HEADWATERS SUBDIVISION, UNITS ONE & TWO

APPLICATION NUMBER 17 DATE July 2, 2009

DETAIL SITE PLAN

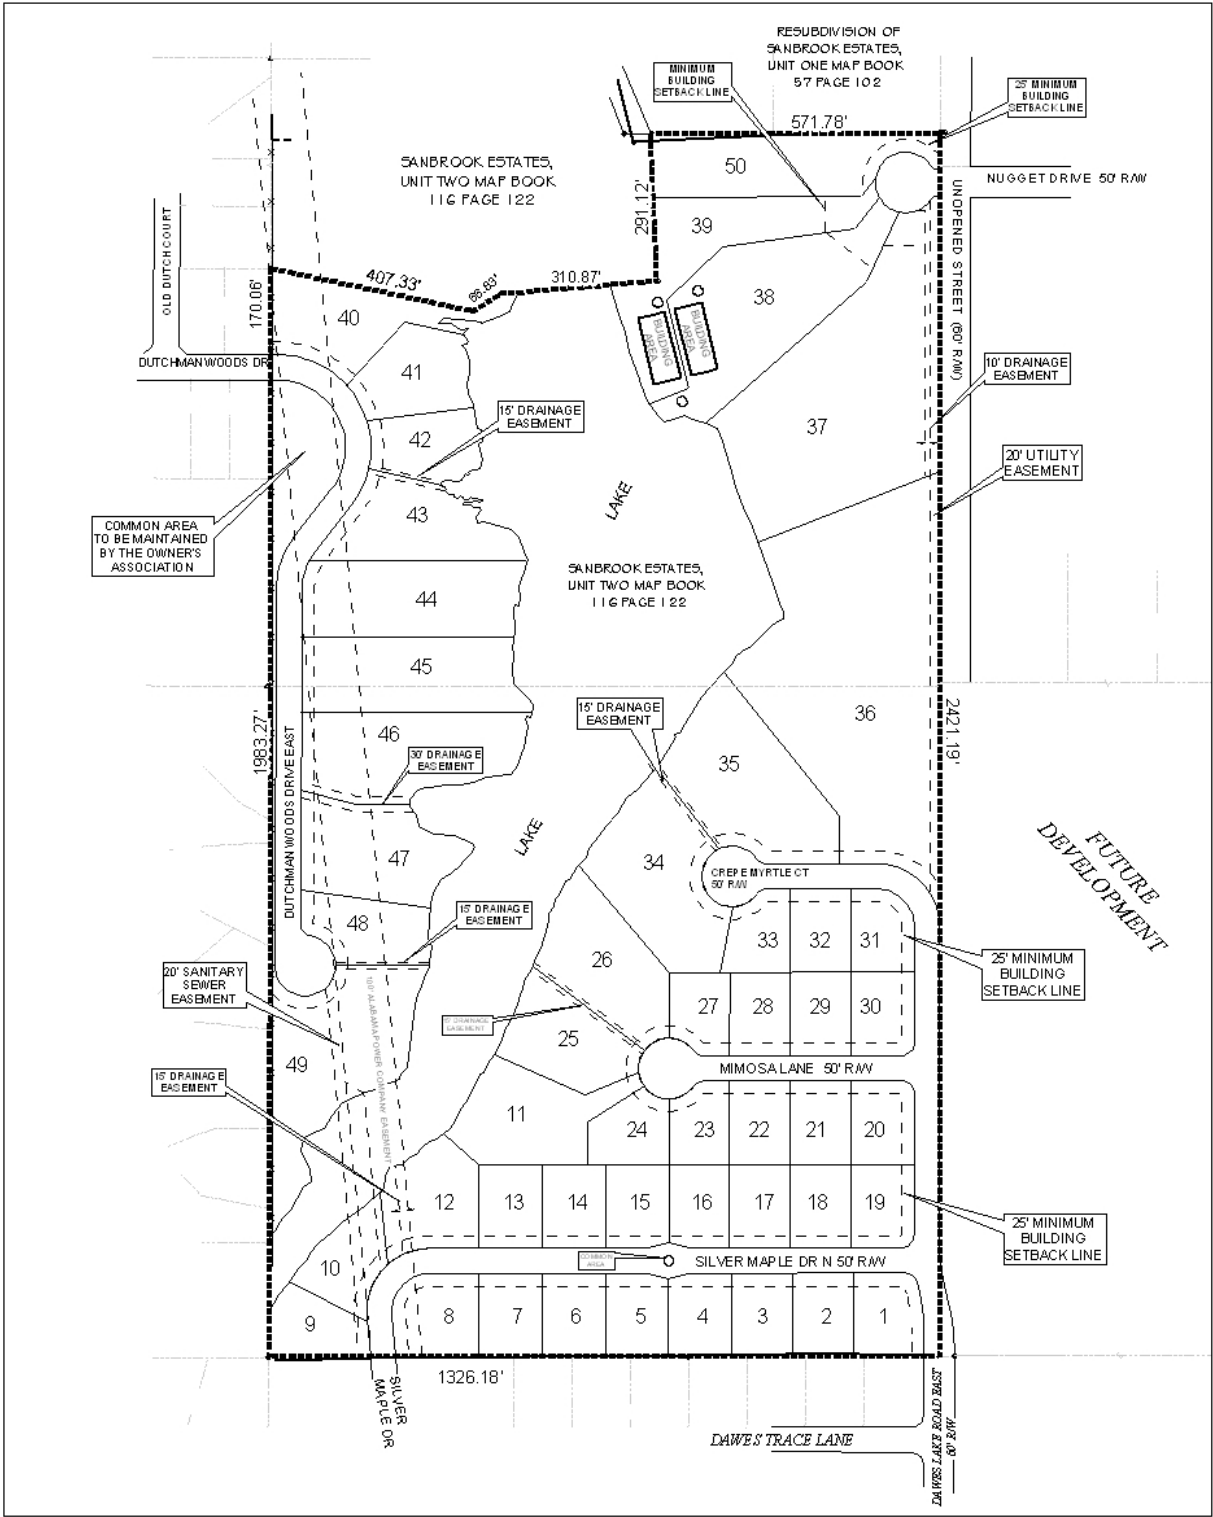
Access management is also a concern. As Lots 1, 8, 19, 20, 30, 31, 36, & 37 are corner lots, a note should be placed on the Final Plat limiting each lot to one curb cut each, with the size, design and location to be approved by County Engineering and conform to AASHTO standards.

As illustrated on the preliminary plat, the site contains a private lake, which indicates that the area may be environmentally sensitive; therefore, the approval of all applicable federal, state and local agencies would be required prior to the issuance of any permits or land disturbance activities.

Detention/retention or common areas are depicted on the preliminary plat; therefore, a note should be placed on the Final Plat stating maintenance of these areas will be the responsibility of the property owners.

- 5) placement of a note on the Final Plat limiting Lots 1, 8, 19, 20, 30, 31, 36, & 37 to one curb cut each, with the size, design and location to be approved by County Engineering and conform to AASHTO standards;

- 6) labeling of all lots with the size in square feet and acres, or the furnishing of a table on the plat providing the same information;
- 7) depiction of the 25-foot minimum building setback lines from all street frontages;

- 8) placement of a note on the final plat stating that any lots which are developed commercially and adjoin residentially developed property must provide a buffer, in compliance with Section V.A.7 of the Subdivision Regulations; and
- 9) placement of a note on the plat stating that maintenance of the detention and common areas is the responsibility of the subdivision's property owners.
